TransCanada Hydro Northeast, Inc.

Project No. 1904-061

ORDER APPROVING FLOW OPERATIONS AND MONITORING PLAN

# Reservoir and Minimum Flow Operations and Monitoring Plan

SECTION AT SLUICE GATE

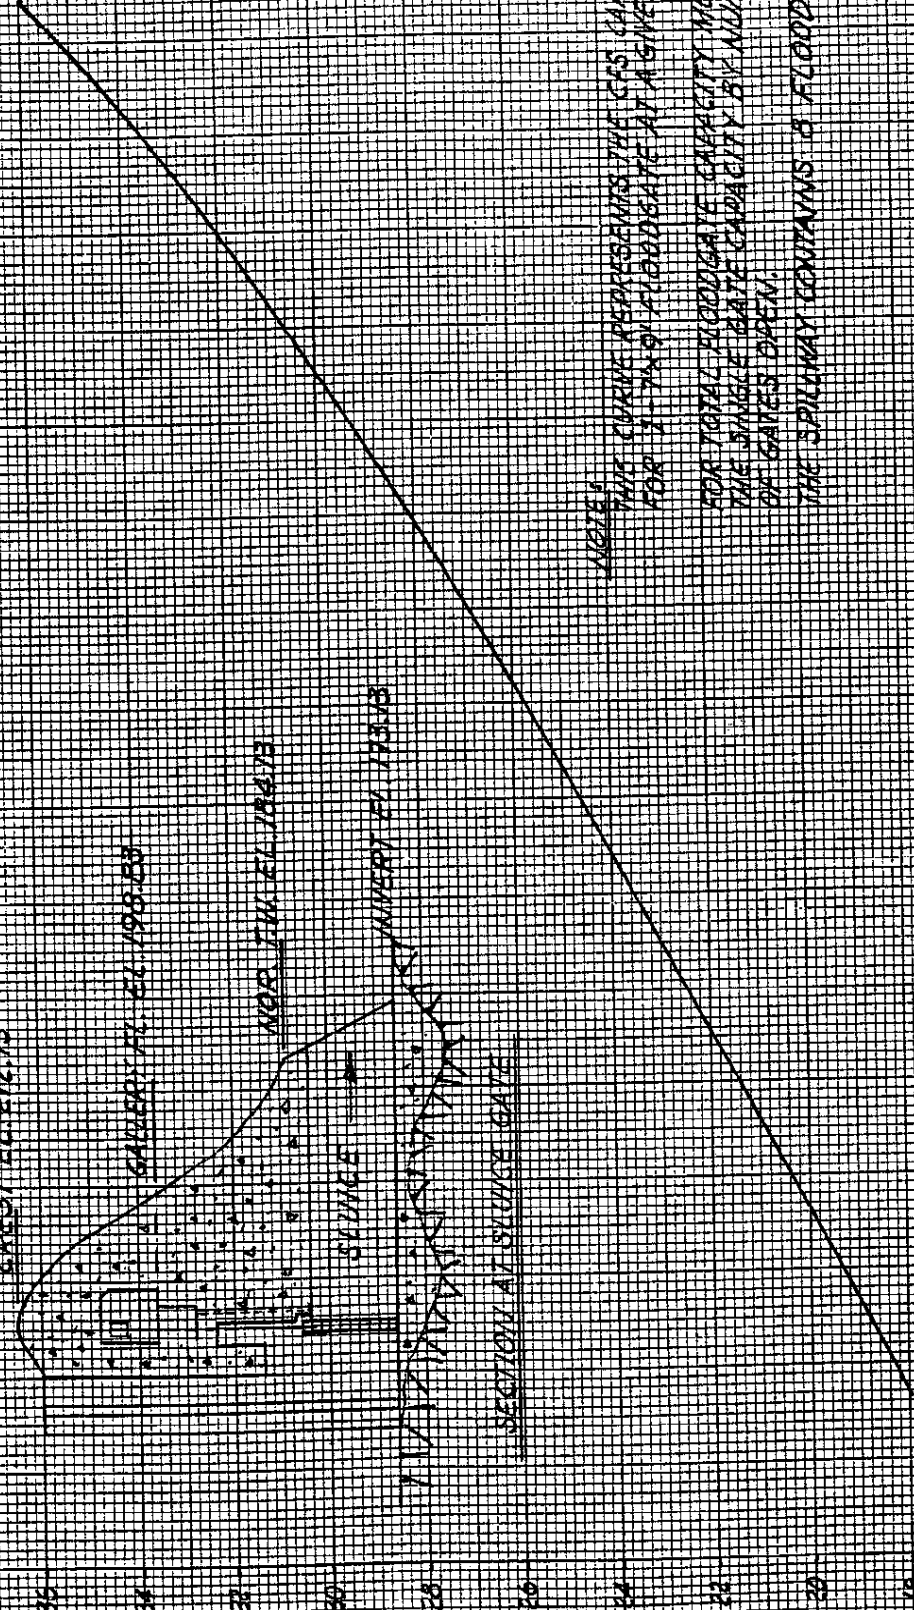
In the revised plan, the text states that the gate just east of the power station will be opened to pass the flows. Is this gate the trash sluice gate described in Appendix C, Figure 7? How are adjustments made to maintain a stable headpond, especially with declining inflows?
